Product Change Notification (PCN)

- 202410 USB type C receptacle middle mount

Note: While responding, please retain "**PCN Notification:509782**" in the e-mail Subject line for faster response.

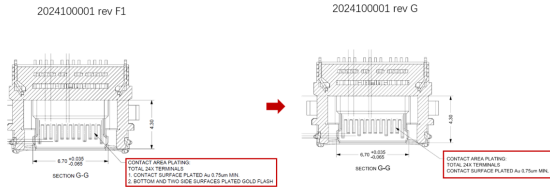
- Change terminal plating SPEC
 - In order to manage product and be easy for manufacture, we standardize plating method and thickness same as other USB-C connector.
 - Remove bottom and side surface gold plating.
- Part Number Impact
 - 2024100001
 - 2024100002
- Qualification Reports and samples available upon request after the date shown above
 - 2021/06/30
